CASE # C15-2010-0154
ROW # 10526383
TP-0202101101

CITY OF AUSTIN
APPLICATION TO BOARD OF ADJUSTMENT
GENERAL VARIANCE/PARKING VARIANCE

STREET ADDRESS: 2401 Santa Maria Street

Variance from Section 25-2-492 (D) to maintain a 2nd story addition providing a side yard setback of 4' along the east property line.

PLOT PLAN

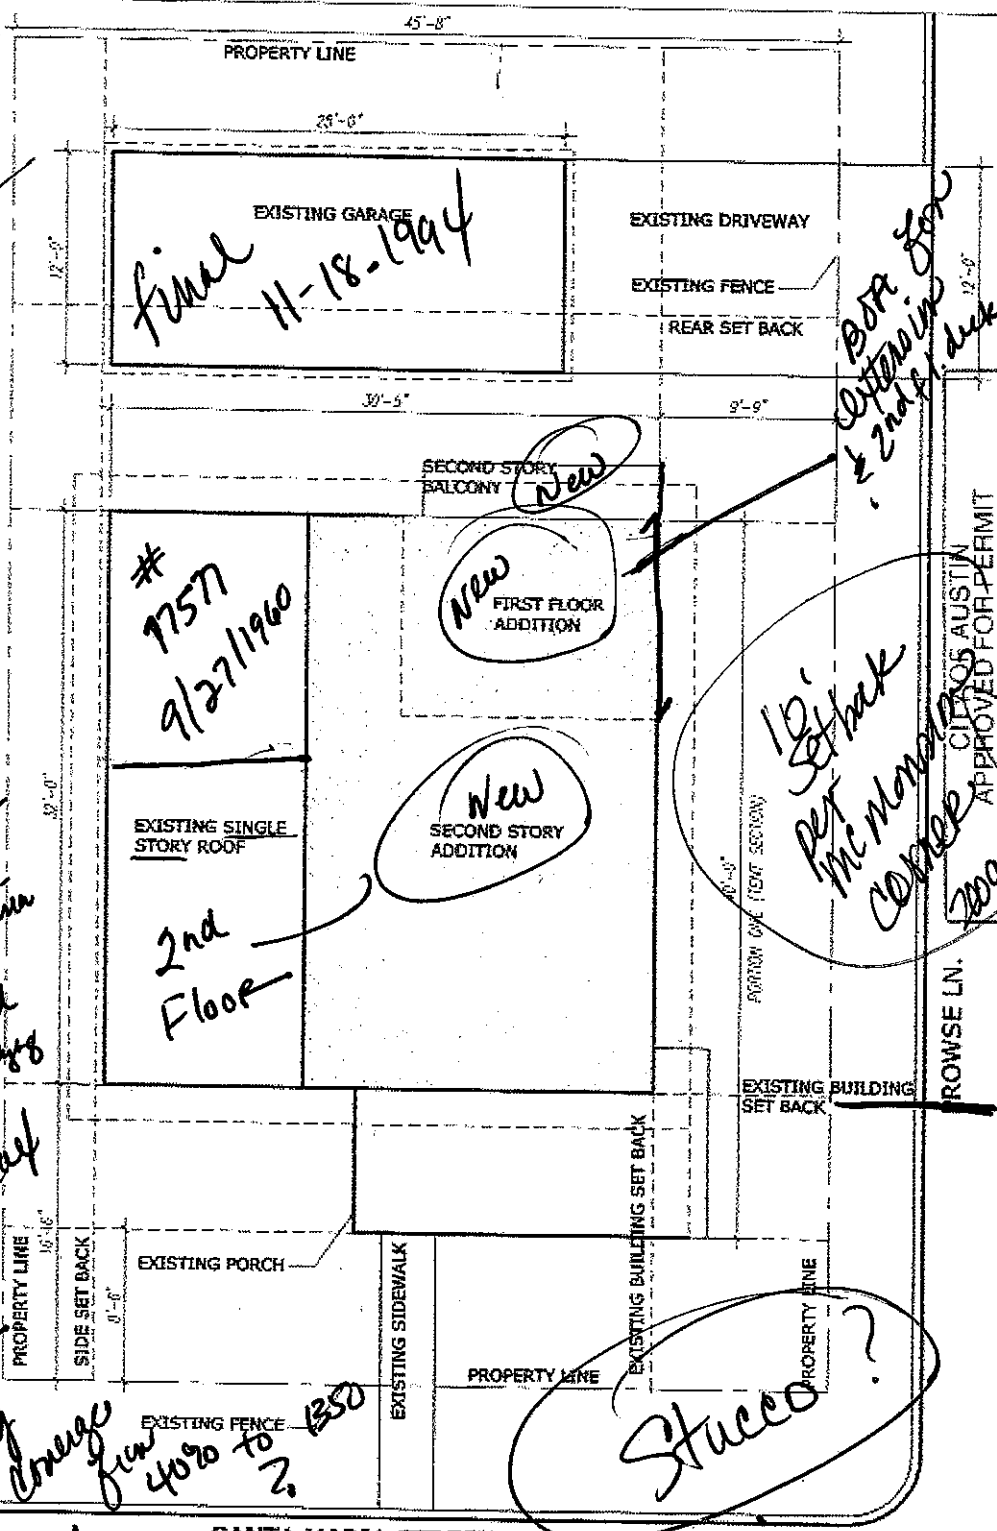
*10' Setback
Street?*

*Building
Change
Order*

*Variation -
1st Fl.
Bldg. Extension
May 10.5
2nd sty extend
along none of the
St.*

*Bldg. Cug May
5' bldg
Setback
Bldg. change
from 40% to 2.*

Setback Average? for 2nd Floor

*10' Setback
per McManis
corner*

PLAT OF SURVEY

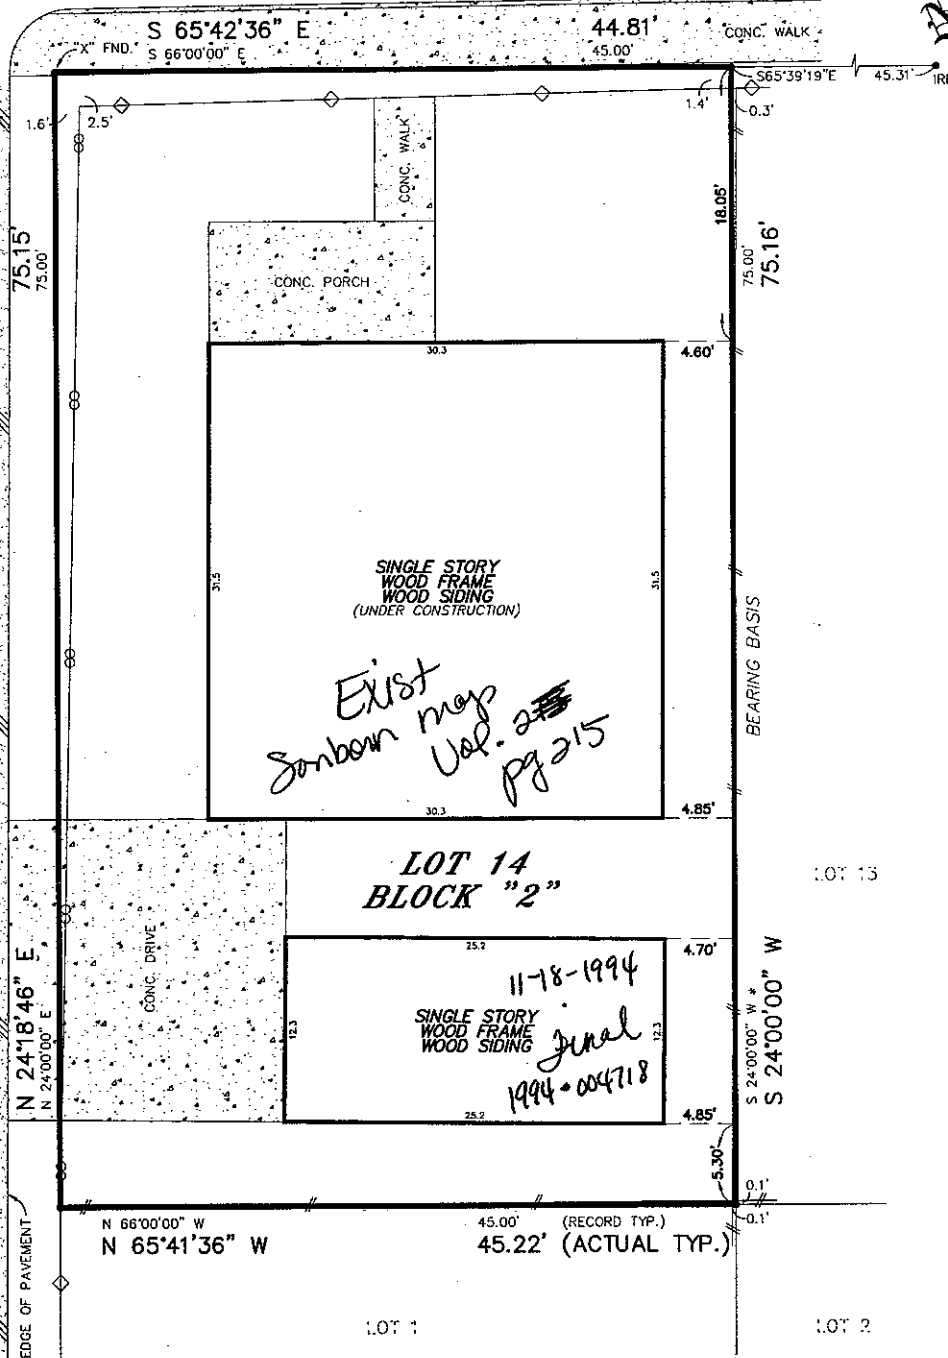
1		103 Framing	11/19/2010	General - add text	Verify side setback requirements are 5'. Owner provided a survey showing 4.7' but said surveyor probably made error and would contact them. Initial layout was passed only with plot plan not with professional stamped survey.
---	--	-------------	------------	--------------------	---

2		103 Framing	11/22/2010	Permitted work must match site conditions. Please contact Inspector.	Revision of Permit required due to Plat Plan showing house to be within 5' B.L. but actual survey showing house to be 4.60 ant one corner & 4.85 at the other with new addition above encroachment
---	--	-------------	------------	--	--
